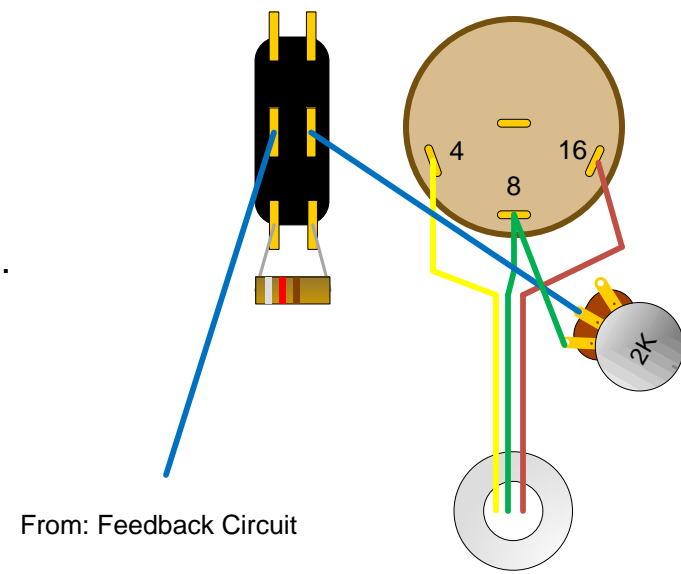
As it is now:
Moving the blue wire
from the switch to the
pot wiper significantly
changes the hum level.

Proposed changes:
The 22Meg resistor is
a complete guess.
Also, adding shielded
wire and making run
from switch to pot
much shorter.
